**BOARD OF ZONING ADJUSTMENT
STAFF REPORT**

5866

New Cingular Wireless PCS, LLC

6311 Cottage Hill Road
(220'± South of Cottage Hill Road, 780'± East of Hillcrest Road)

DETAIL SITE PLAN

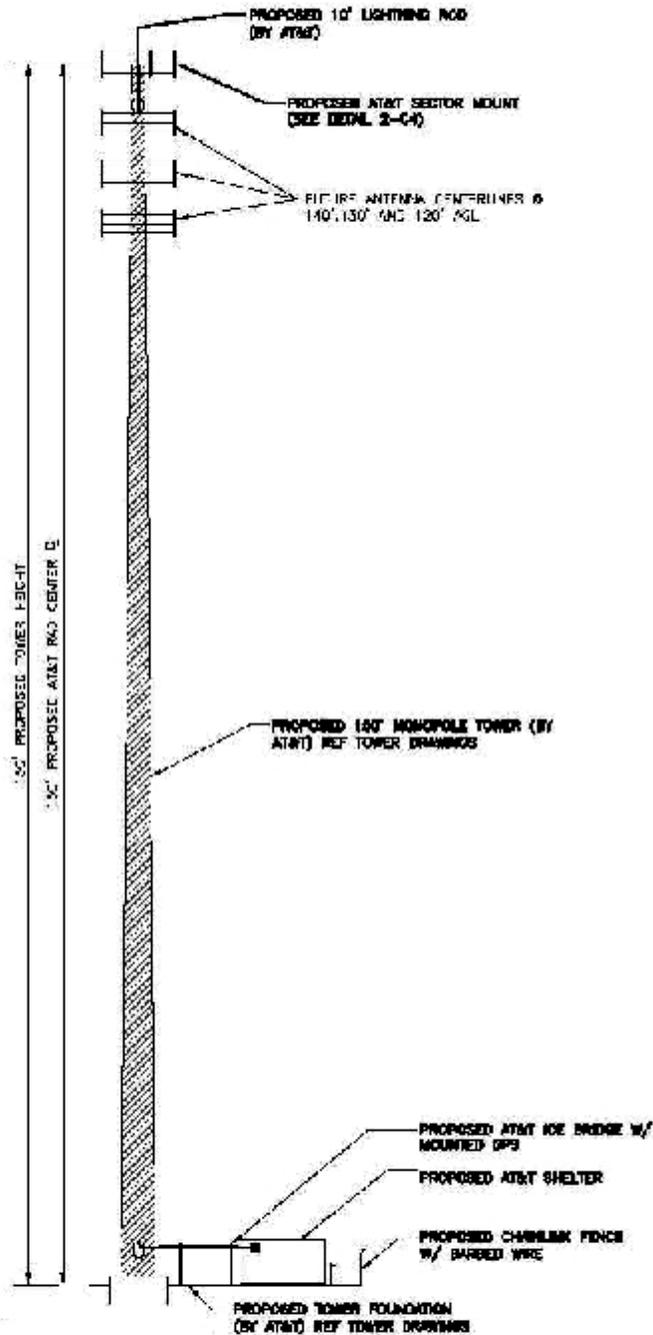
The site plan submitted indicates only evergreen shrubs proposed to be planted around the interior of the lease parcel and the applicant requests a Tree Planting Variance due to the proposed site mostly being surrounded by existing mature trees. However, some trees would have to be removed to develop the tower site and no hardship has been illustrated to justify the granting of the Tree Planting Variance request, especially in light of the fact that sufficient area would be provided by the clearing for the tower lease parcel to provide the required number of trees.
